INDESIT company

Model type:
TAN2S

Commercial code:
F034169

51421M0

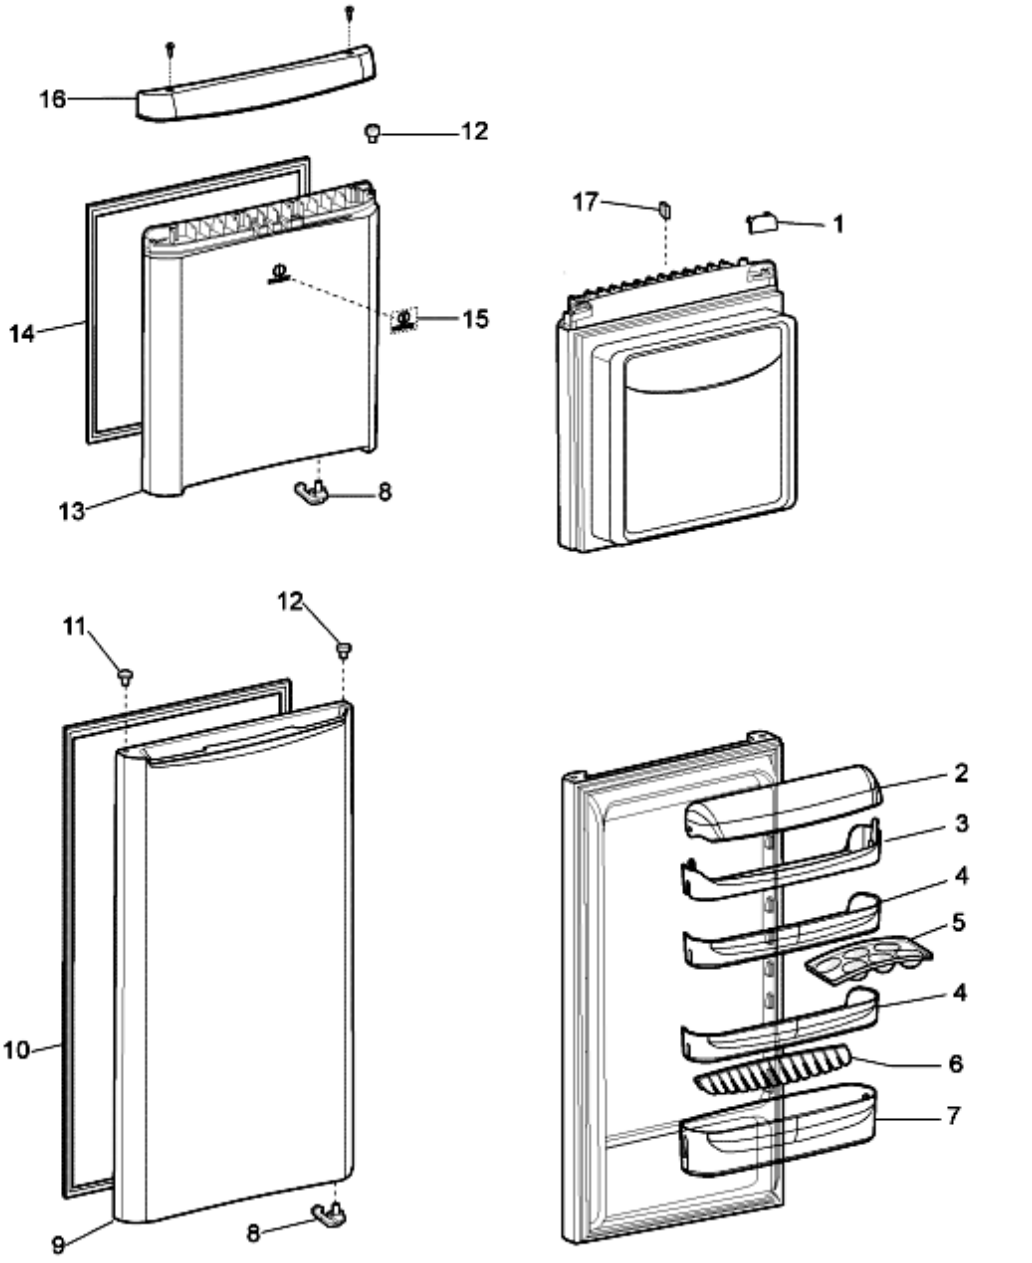
n2507b01: Color change on inner door upper heading

From s/n 70129.0001 (January 2007) on teak – inox – silver Indesit models has been introduction in production a new white inner door upper heading / white hinge blanking plate.

The spare part code of the door remain the same.

When replacing the door in the products produced before the modification replacing also the brown hinge blanking plate (for teak versions), grey (for silver version), aluminium (for inox versions) with the white.

n2511b02: ELIMINATION COVER FOR UPPER DOOR SHELF-INTERNAL ACCESSORIES RESTYLING

Cover for upper door shelf has been eliminated. The upper door shelf has been standardized with the middle one. Subsequently has been standardized with transparent internal accessories instead of those in light blue colour once stock has depleted.

5142260 Exploded views

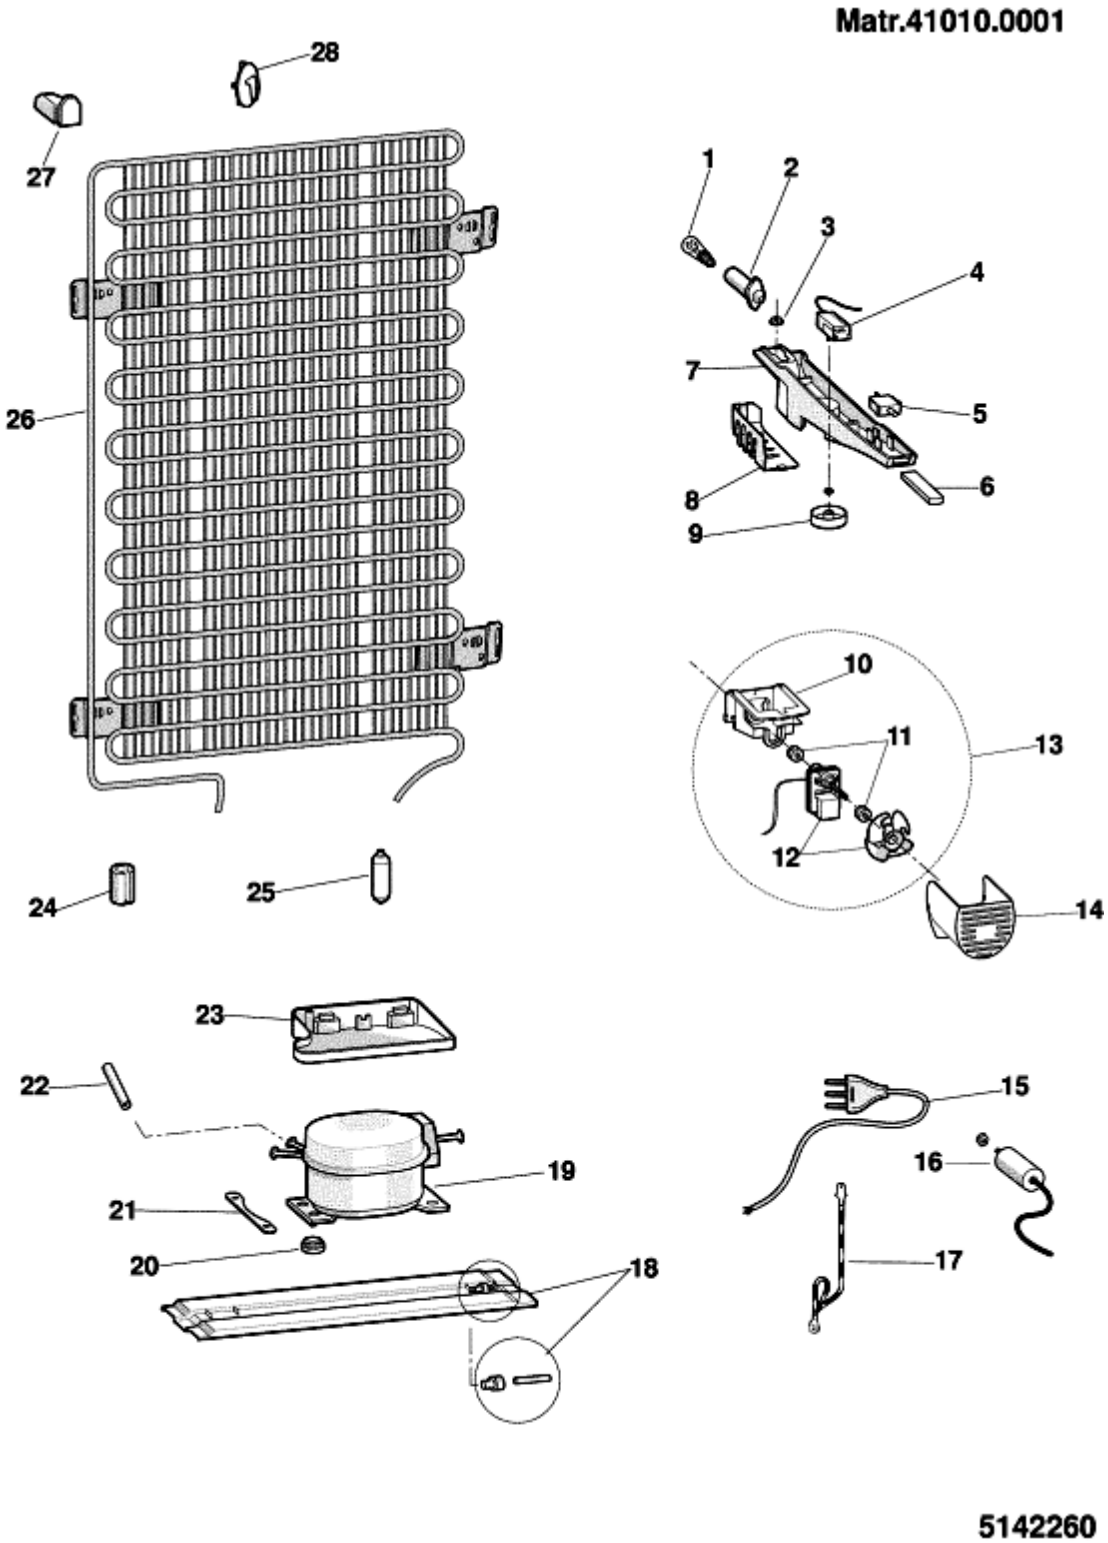
n1025101: Disappearing bulb thermostats (warning!)

The apparatus that provide for the thermostat to be threaded into a small tube located inside the fridge cabinet are noted as versions with "disappearing bulbs".
The bulb must be inserted for a length equal to the position indicated on the colored ribbon (small mark) which confirms the correct position of the bulb in the evaporation area, otherwise causing the poor performance of the apparatus.
Therefore in cases of thermostat replacement it will be necessary to reset on the new, if missing, the same small mark position and always check that the thermostat bulb is completely devoid of the sheath so as to ease its insertion.
The entrance of the small tube, placed in the thermostat container, is protected by a perforation cover in order to avoid the formation of condensation. The perforation cover was initially situated externally and could be substituted with putty or silicone.
For the models with disappearing bulb thermostats, the spare parts are inclusive of the small colored marker,

however check that its position corresponds to that on the thermostat that will be replaced.
The spare part description always notes the position of the small marker in millimeters as well as the thermostat initials.

n1025135: Thermostat box on Indesit/Ariston Opera-60 refrigerators (low A.T. +16°C)

As of July 2003, two new "Low ambient temperature thermostat box kits" have been introduced as spare parts for Ariston Opera-60 and Indesit 2000 - 2002 - 2003 range refrigerators with Giugiaro thermostat box (075646).

The two kits have a different thermostat (remember to always check the position of the mark).

The kit must only be used to solve freezer performance problems caused by an ambient temperature below +16° C.
This innovative kit features a DIODE, activated by means of the luminous switch, which makes the thermostat box lamp turn on. It must be activated when the ambient temperature falls below +13°C (closed contacts: see the wiring diagram that comes with the kit).
The heat produced by the lamp activates the thermostat, thus ensuring regular operation of the appliance.
When replacing the thermostat box, no component can be reused (including the wiring).
The kit wiring has pin terminals for connection to the terminal block on the compressor; some modifications may be required for other solutions.
Given below is the list of kit items available as spare parts:
